## Authors' Response to Reviews of

# Low-level buoyancy as a tool to understand boundary layer transitions

*Atmospheric Measurement Techniques*, 2021–68

Figure 1: Time series of solar irradiance ( $\text{W m}^{-2}$ , brown line), Mesonet 9 m temperature ( $^{\circ}\text{C}$ , blue line), CopterSonde temperature ( $^{\circ}\text{C}$ , black dot), and radiosonde temperature ( $^{\circ}\text{C}$ , red dot) on 05-06 October 2018

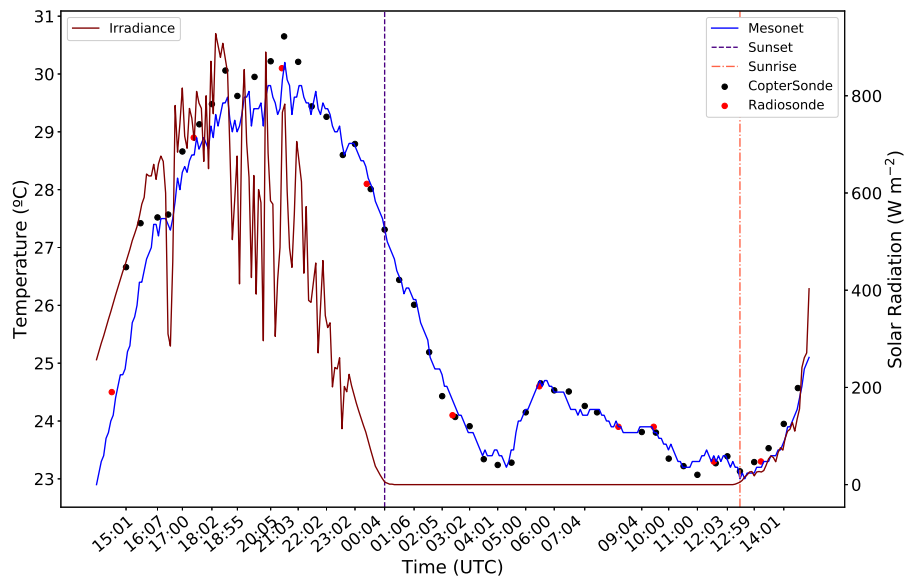
**RC:** *Line 182: “Moreover, the warm bias reduces to near-zero at 2103 UTC.” For me this is already the case for 18:30! It would be nice to have the time series of global irradiance to see e.g., the effects of cloudiness in the afternoon reducing/avoiding this warm bias.*

AR: Figure 1 does not suggest that there is a correlation between irradiance and the warm bias. The timing of when the bias is reduced has been changed from 2103 to 1607 UTC in the text.
